**FINAL  
ENVIRONMENTAL IMPACT  
STATEMENT  
FOR  
LONG-TERM DEVELOPMENT  
PLAN CONCEPT  
AND SHORT-TERM SUBDIVISION  
PROPOSAL FOR  
SAN JUAN-FIDALGO PROPERTIES**

**ERRATTA SHEET FOR FINAL EIS  
FOR LONG-TERM DEVELOPMENT PLAN  
CONCEPT AND SHORT-TERM SUBDIVISION  
PROPOSAL FOR SAN JUAN-FIDALGO PROPERTIES**

**FINAL  
ENVIRONMENTAL IMPACT STATEMENT  
FOR  
LONG-TERM DEVELOPMENT  
PLAN CONCEPT  
AND SHORT-TERM SUBDIVISION  
PROPOSAL  
FOR SAN JUAN-FIDALGO PROPERTIES**

Figure 1  
**LOCATION  
MAP**

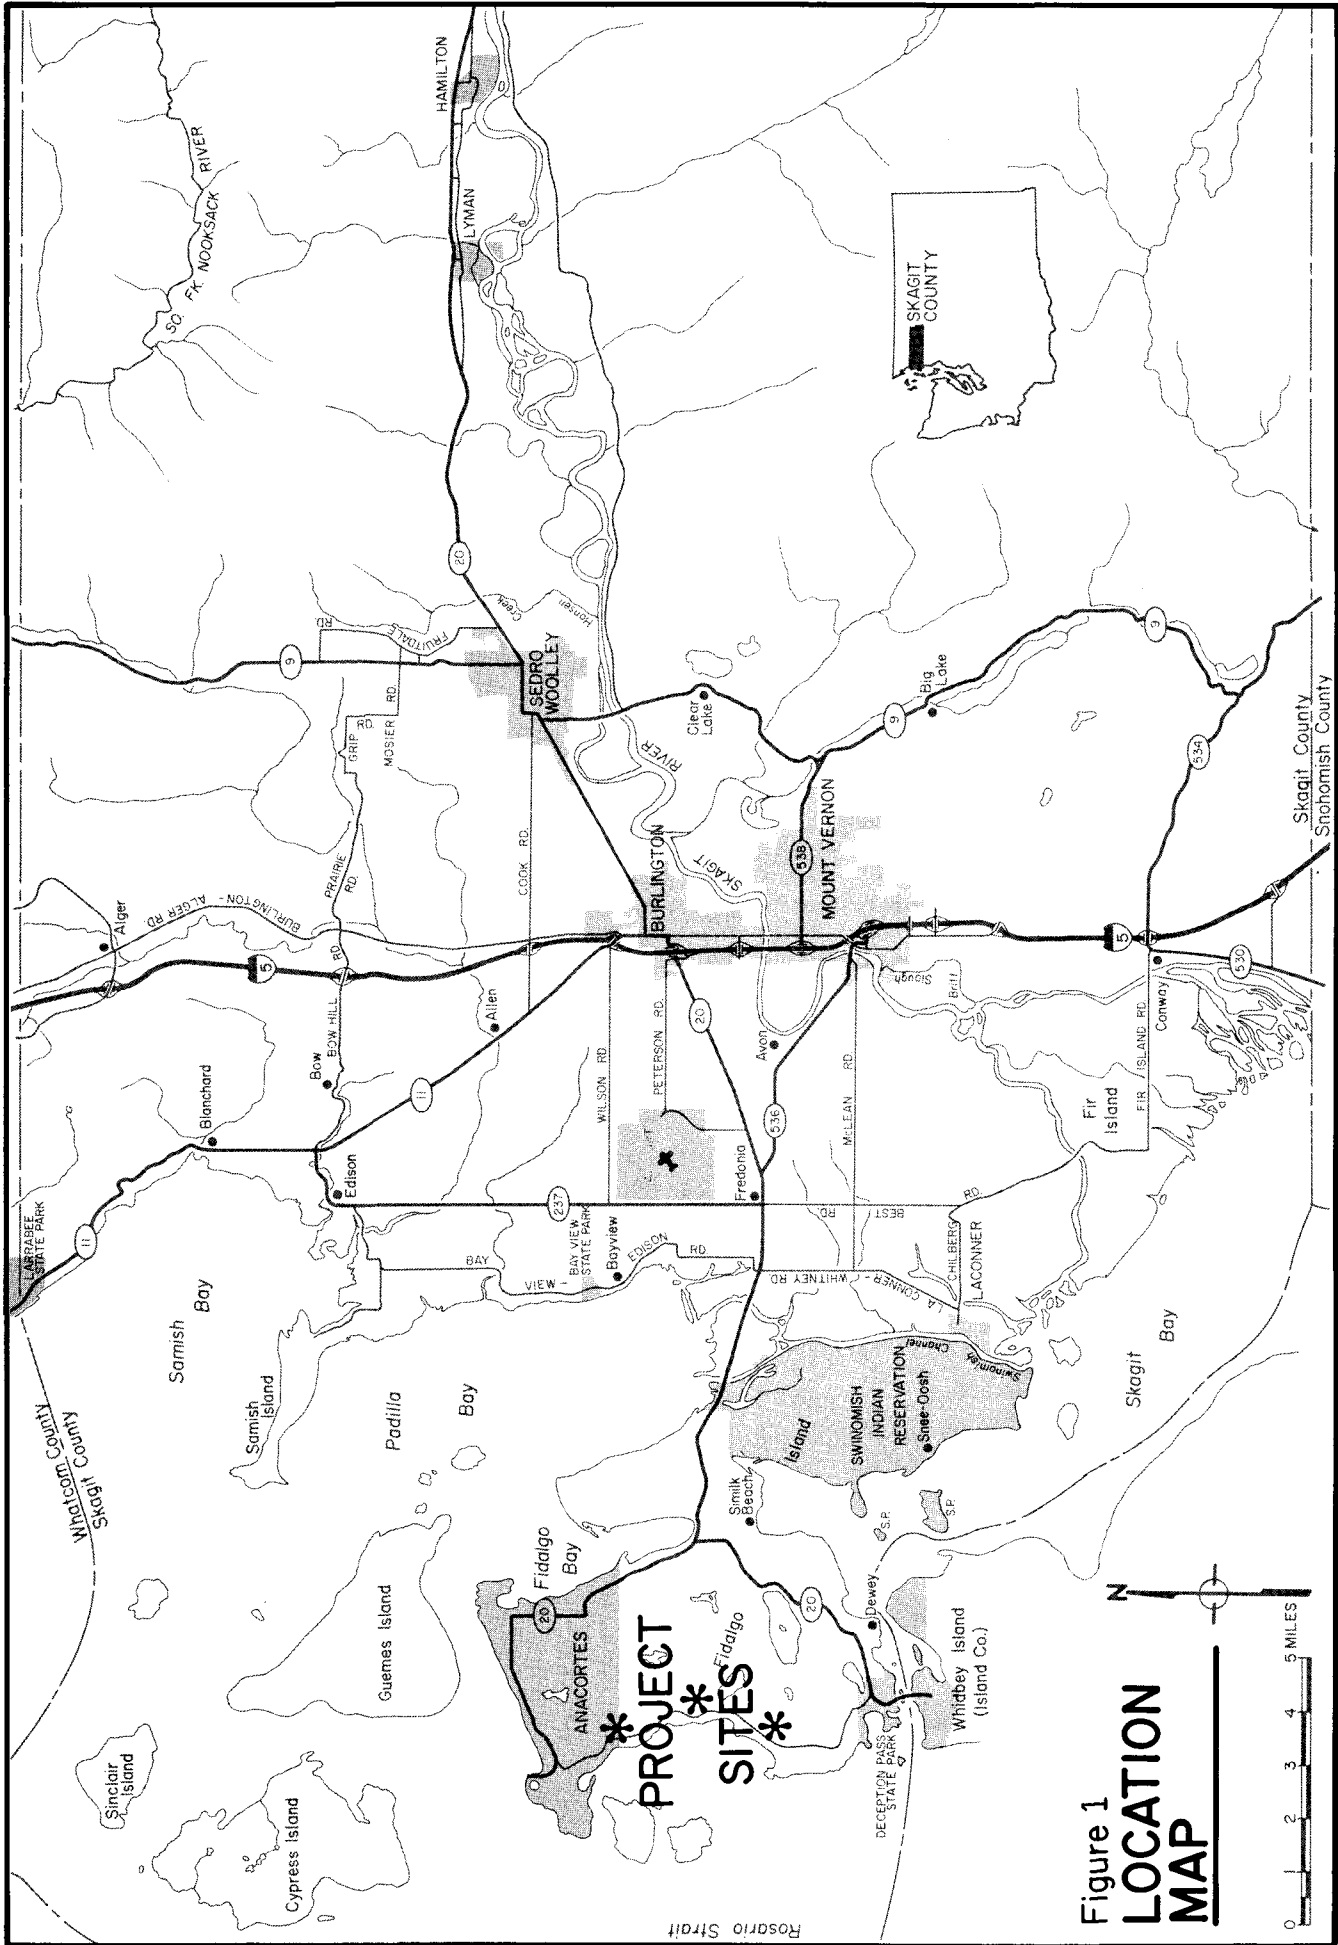
Figure 1 Show the Anacortes airport; it can be identified on other maps  
if one knows to look for it. Very close to the Pointe, the  
noise factor can be expected to increase in the future.

JANUARY, 1990  
DRAINAGE PLAN

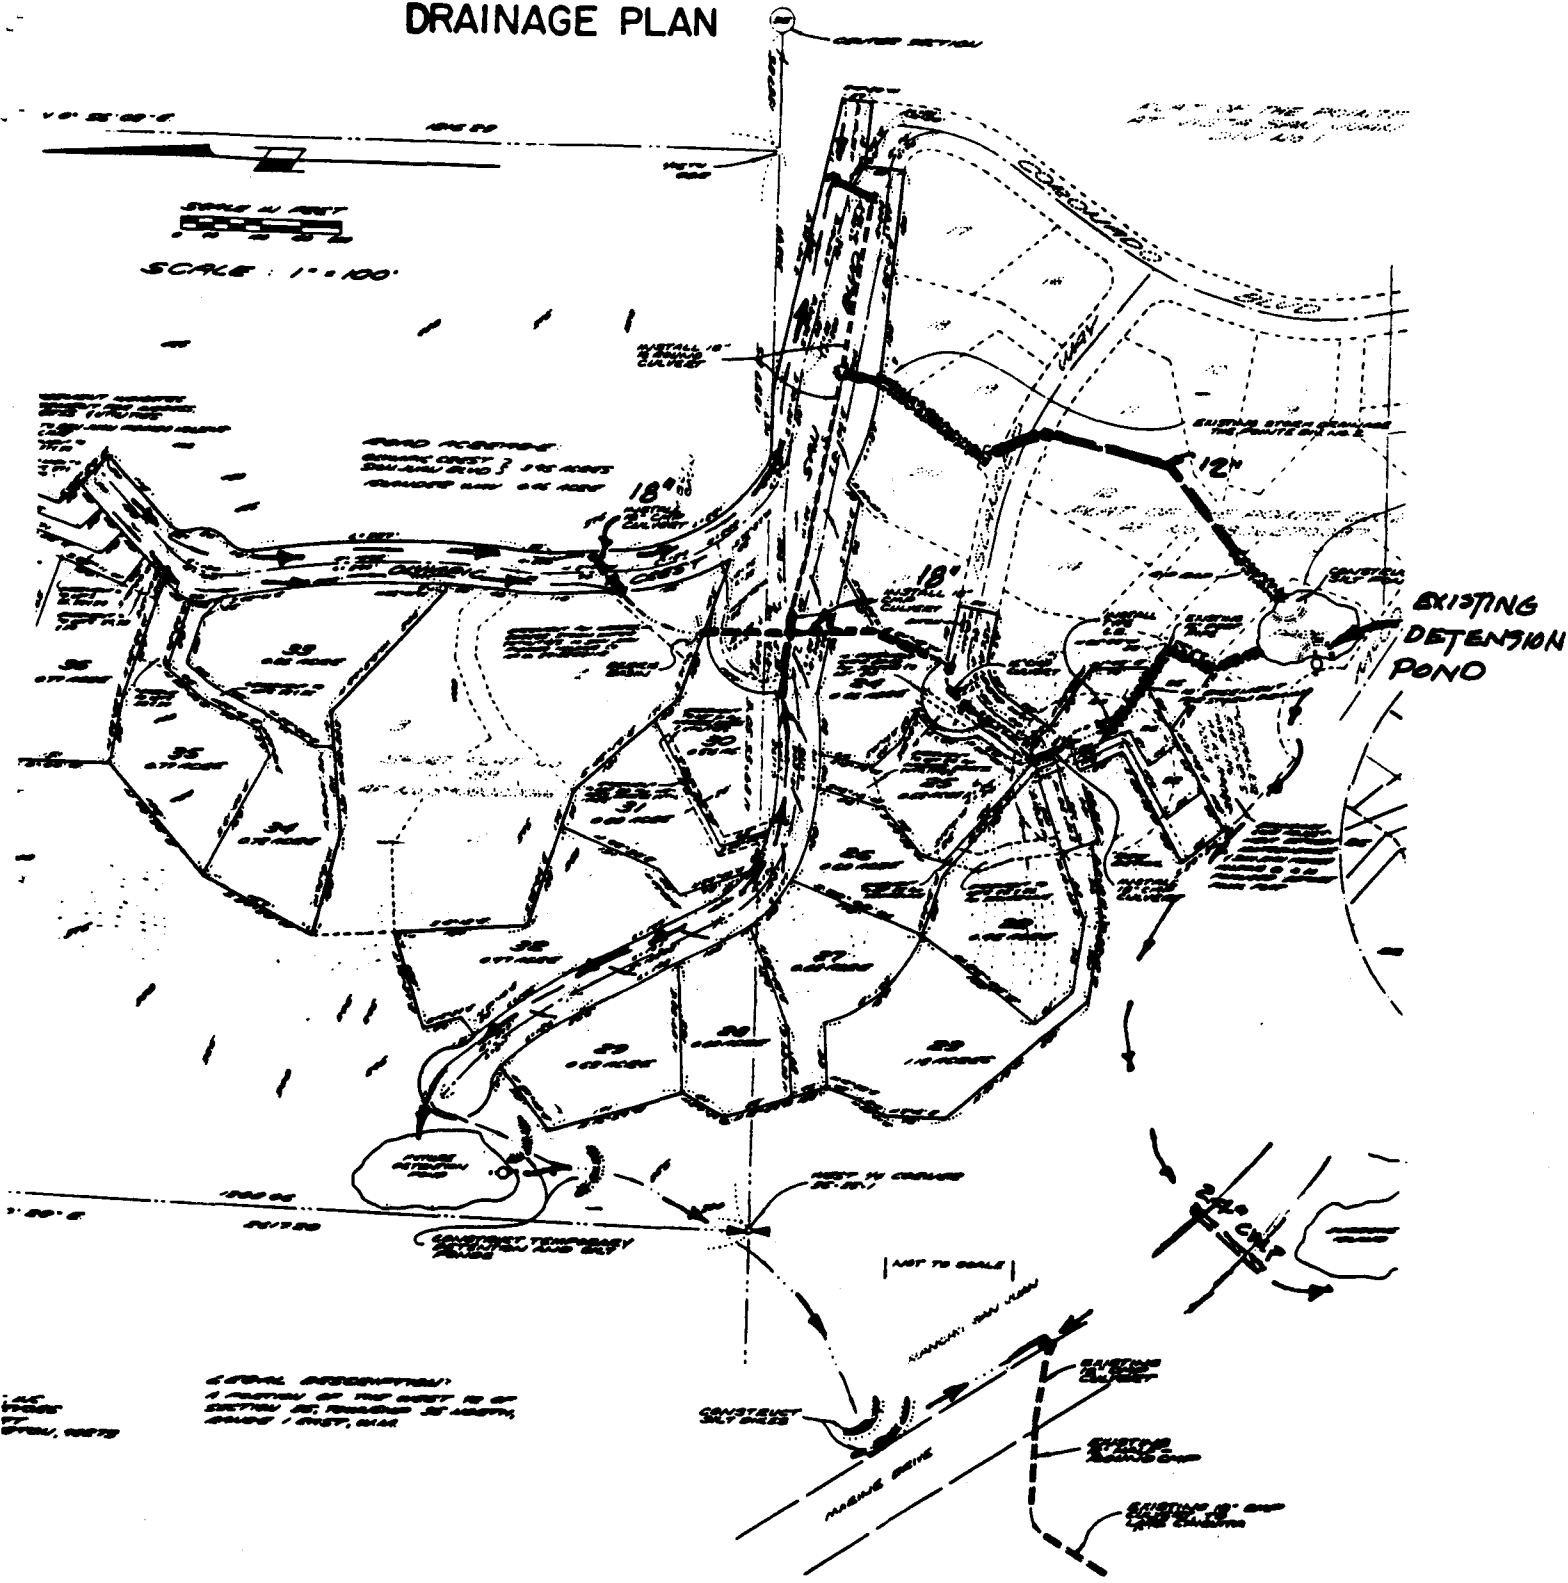
Prior to consideration of Seaview IV and V, the County should require detailed drainage plans for the site (including flows to the east at Devils Elbow) and outline the required erosion and sediment control measures to be undertaken during construction. These plans and measures should assure downstream owners that no runoff volume above existing levels will result from development.
